Basin Bridge Project Traffic and Transportation Effects Peer Review

Job No.	Prepared by	Verified by	Approved by	Status	Issue No.	Date
4319	AD/DS/PD	DS/PD	PD	Draft	1	22/11/2013
4319	AD/DS/PD	DS/PD	PD	Final	1	25/11/2013

Figure 3.6 Arthur St Intersections Comparison

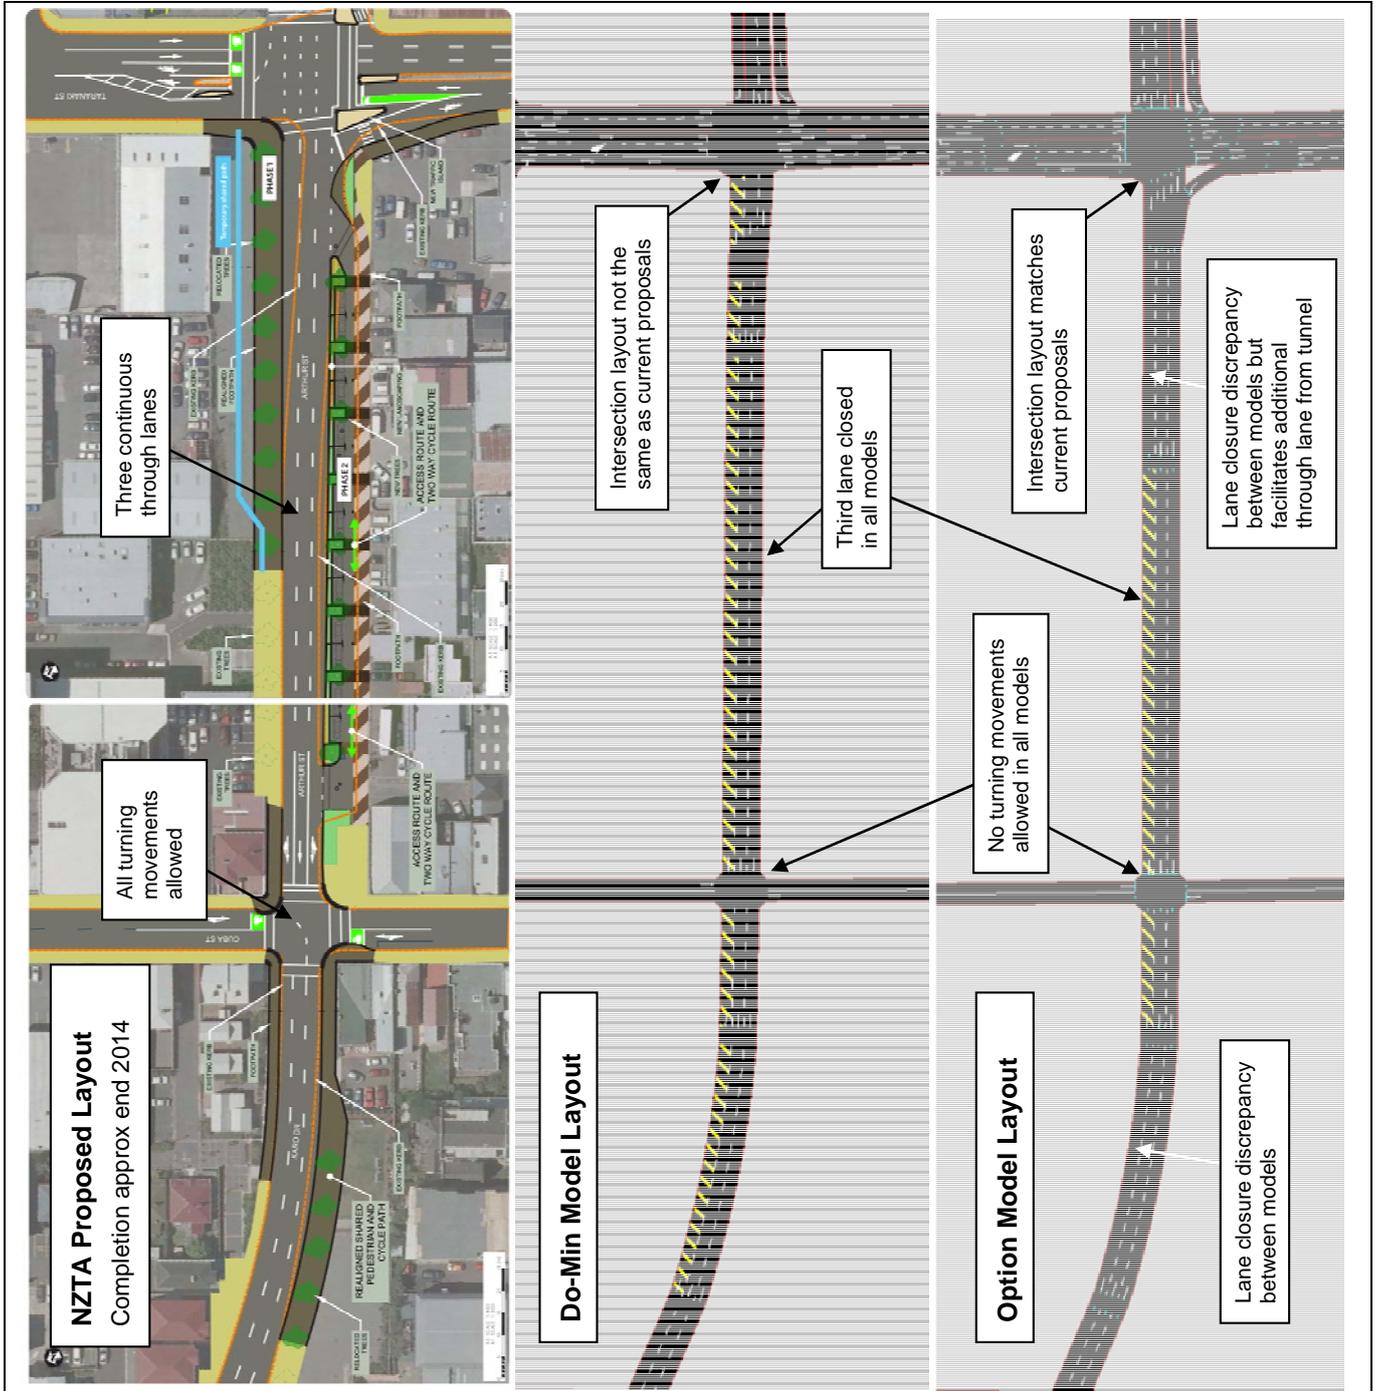
- 3.83 The proposed improvements on Arthur Street between Taranaki and Cuba Streets as taken from the NZTA website are shown in **Figure 3.6** as well as the modelled layout for this corridor in the do-minimum and proposed networks. The most significant difference is the inclusion of three continuous lanes from Taranaki Street through to Victoria Street on Arthur Street whereas there are only two lanes which are operational in the model (the model does include a third lane but it is closed).

- 3.84 It is unclear from supporting documentation what the correct treatment along Arthur Street should be between Taranaki Street and Victoria Street, however the treatment of the corridor to the east of Taranaki Street and the layout of the Taranaki St intersection are consistent with TR4.

- 3.85 Further to this there are some minor discrepancies between the coding of the do-minimum and proposed networks along this corridor. These are annotated in Figure 3.6 alongside the Buckle Street road layout from the NZTA website. Confirmation is requested to determine whether the do-minimum and proposed networks have been

treated correctly along this corridor, and that the do-minimum network accurately reflects the operation of Arthur Street following the completion of the Buckle Street underpass.

48	It is not clear whether the do minimum improvements in the vicinity of the Buckle Street underpass are coded accurately to the west of Taranaki Street and these are not consistent with current ICB improvements proposed on the NZTA website. This is raised as issue 4 above and further comment would be appreciated as to whether the do minimum and proposed networks reflect these changes appropriately.	s-Paramics files	3.83-3.85	Unclear	Recommend that NZTA provide comment
49	The bus lane restrictions southbound on Dufferin Street should cease around 30m short of the stop line so that all traffic can use both lanes southbound on Dufferin Street. Comment on the extent to which this may change the model performance is requested.	s-Paramics files	3.91	Minor	Recommend that NZTA provide comment

Figure 3.7 Eastern Overbridge Connection Comparison

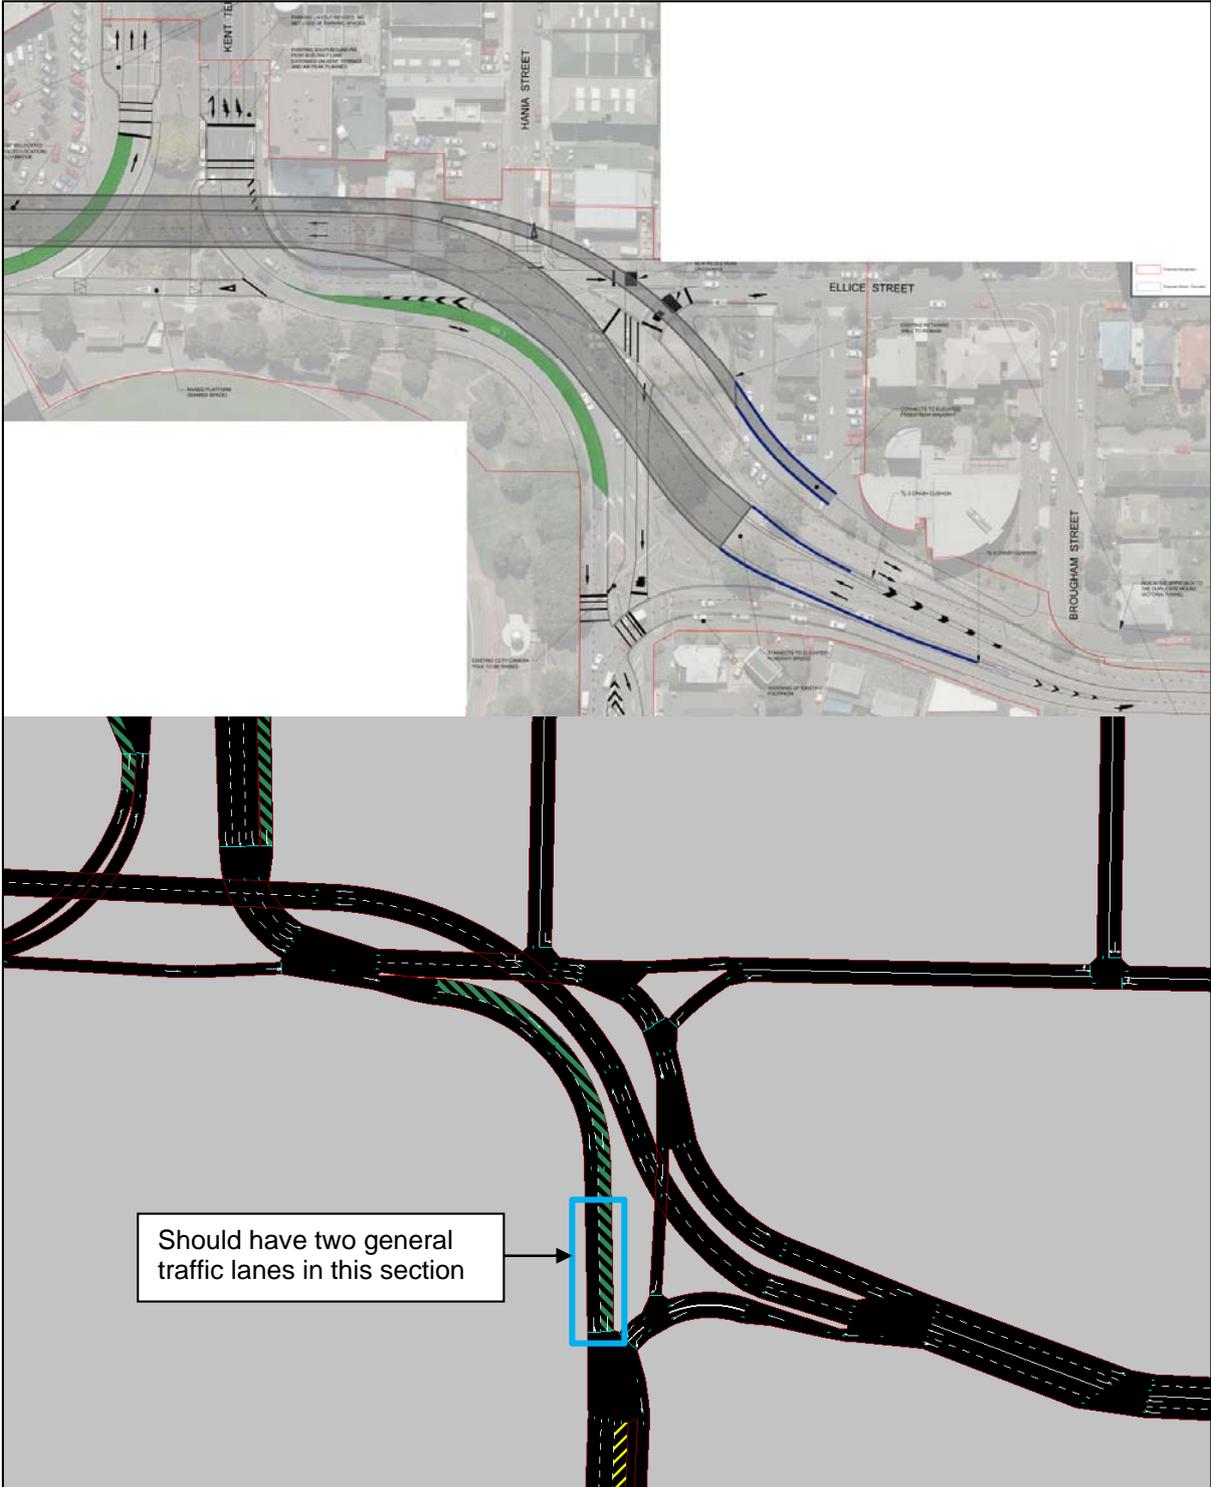
- 3.91 The changes in this location associated with the proposed overbridge are shown in **Figure 3.7** as well as the modelled layout. The model reflects the proposed plan well except for the bus lane on Dufferin Street. The bus lane restrictions cease around 30m short of the stop line at the intersection where SH1 traffic enters the Basin Reserve gyratory so that all traffic can use both lanes southbound on Dufferin Street.
